**Application No.:10/782,574**

**Docket No.: JCLA12196**

**REMARKS****Present Status of the Application**

FIG. 4 (PRIOR ART)

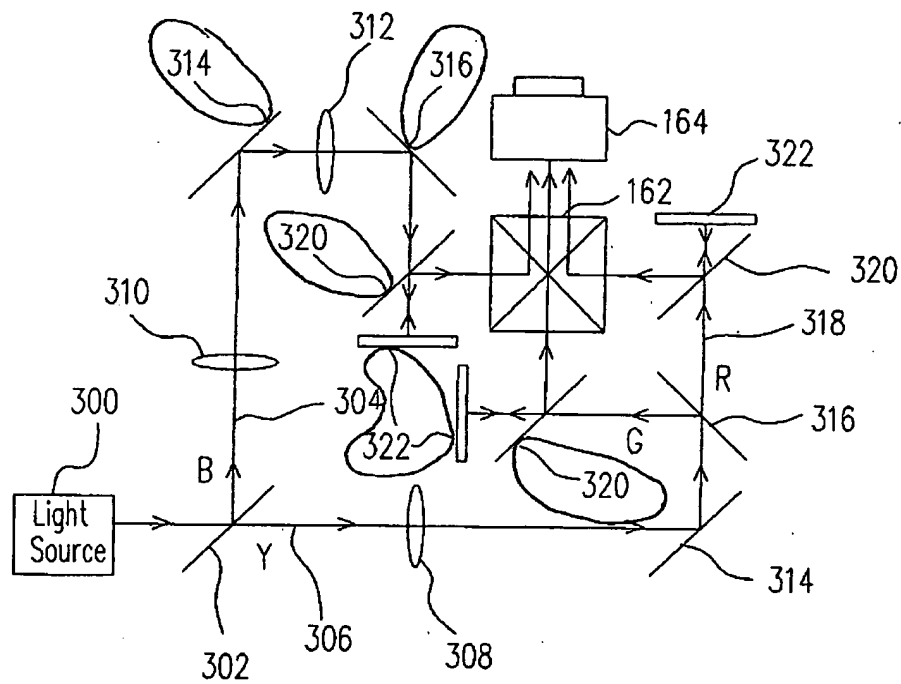
Please amend Figures 4, 7, 9, 10 and 11 as shown in red ink in the separate accompanying pages. Proposed corrected drawing including corrected Figures 4, 7, 9, 10 and 11 is also attached hereto in separate accompanying pages. Reconsideration is respectfully requested.

FIG. 4, 7 and 9-12 have been amended to overcome the Examiner's objections as set forth on page 2 of the outstanding Office Action. Proposed corrected FIG. 4, 7 and 9-12 are attached hereto as separate accompanying pages. Reconsideration is respectfully requested.

FIG. 7

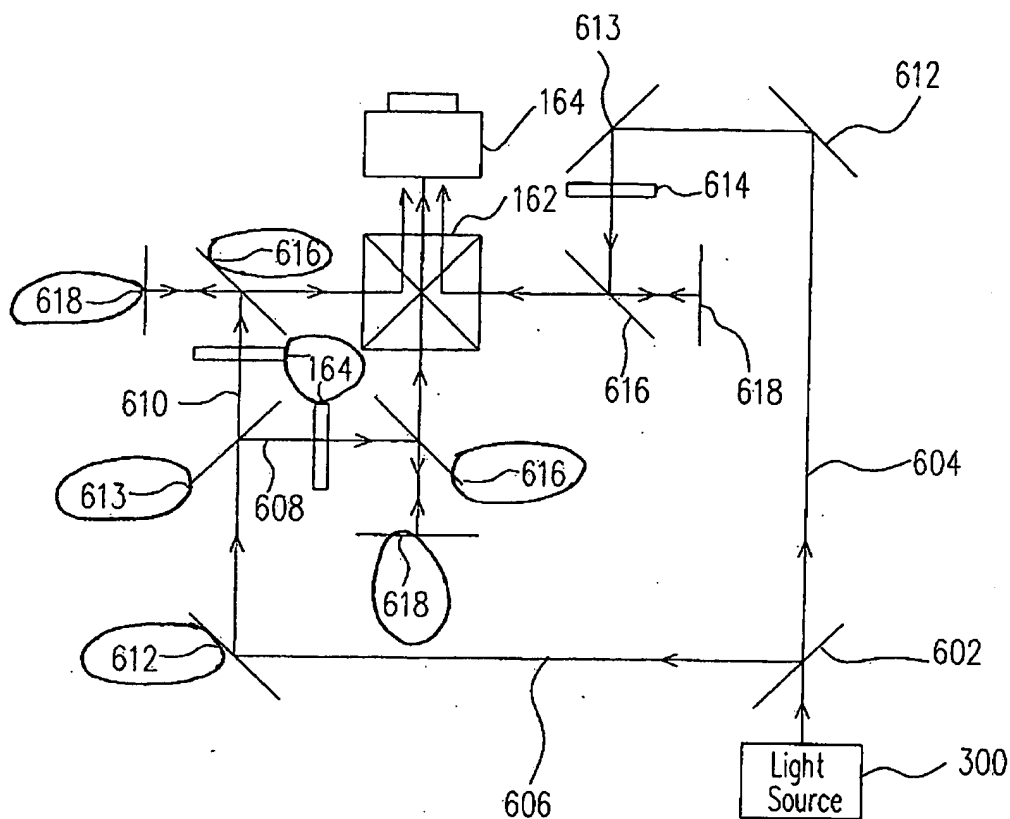
*The Office Action objected to the drawings under 37 CFR 1.121(d) because Figure 7, for example, only one of the three wire grid polarizers and one of the liquid crystal panels, element number 616 and 618 respectively, are labeled and requests for labeling the remaining two of the three wire grid polarizer and the liquid crystal panels.*

In response thereto, Applicants would like to thank the Examiner for pointing out the informalities and accordingly corrected the drawings as above. Reconsideration is respectfully requested.
